PG&E Letter DCL-20-066

Diablo Canyon Units 1 and 2
Docket No. 50-275, OL-DPR-80
Docket No. 50-323, OL-DPR-82
License Amendment Request 20-01
Exigent Request for Revision to Technical Specification 3.7.5, "Auxiliary Feedwater System"

Evaluation of the Proposed Change
License Amendment Request 20-01
Exigent Request for Revision to Technical Specification 3.7.5,
“Auxiliary Feedwater System”

Figure 1 – Auxiliary Feedwater Simplified System Diagram

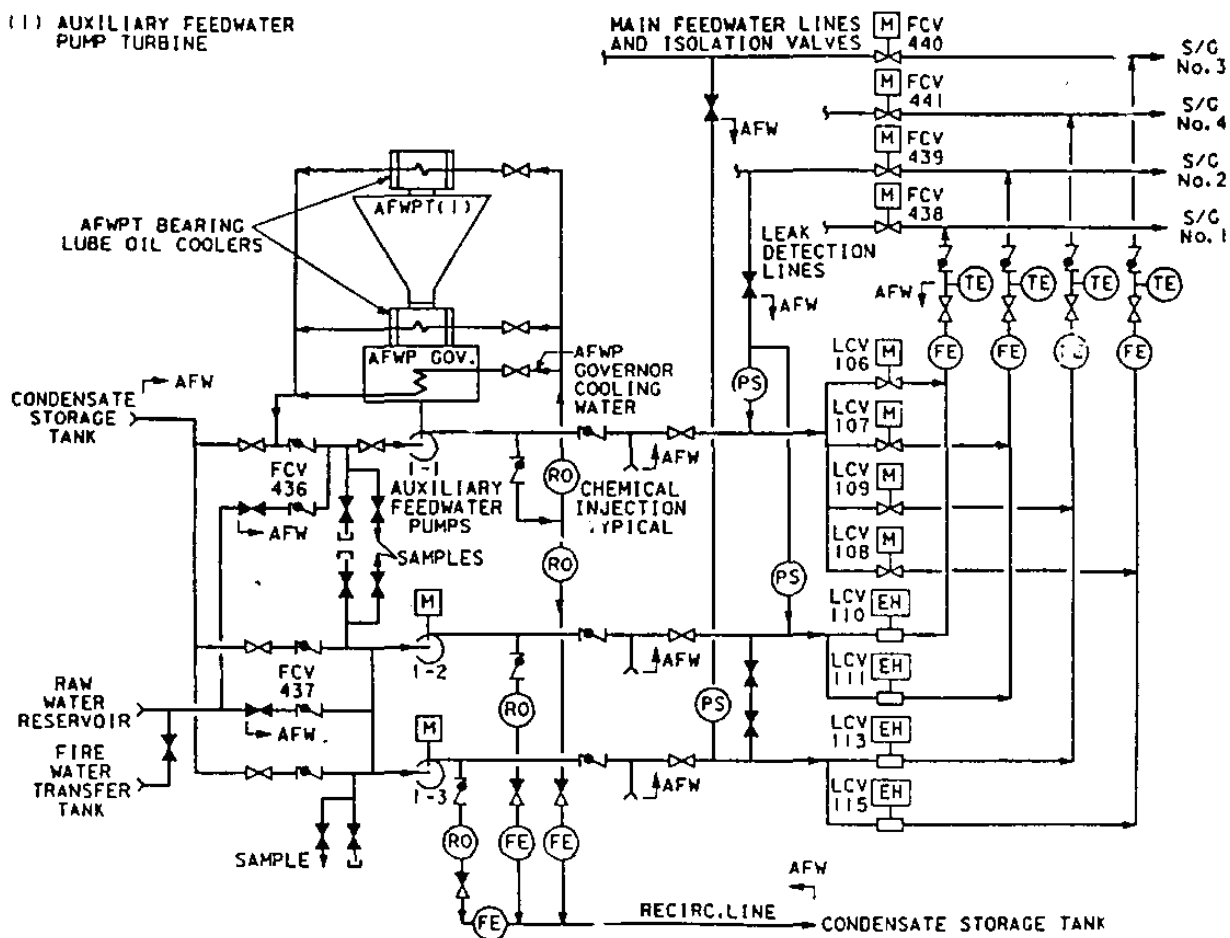
The turbine-driven pump is actuated by 12 kilovolt (kV) bus undervoltage or SG low-low level in two of four SGs via the Emergency Safety Feature Actuation System. A simplified diagram of the AFW is provided in Figure 1.

The turbine-driven Pump 1-1 discharge lines include level control valves (LCV) to the SGs; LCV-106 to SG 1-1, LCV-107 to SG 1-2, LCV-108 to SG 1-3, and LCV-109 to SG 1-4 that can be operated from the Control Room. The Unit 1 piping between LCV-107 and SG 1-2 includes Line 570, which contains piping and elbows that potentially may not meet minimum code thickness requirements and could require repair.

The motor-driven Pump 1-2 discharge lines include LCVs LCV-110 to SG 1-1 and LCV-111 to SG 1-2 and motor-driven Pump 1-3 discharge lines include LCVs LCV-113 to SG 1-4 and LCV-115 to SG 1-3 that can be operated from the Control Room. The Unit 1 piping between LCV-111 and SG 1-2 includes Line 576, which contains piping and elbows that potentially may not meet minimum code thickness requirements and could require repair.
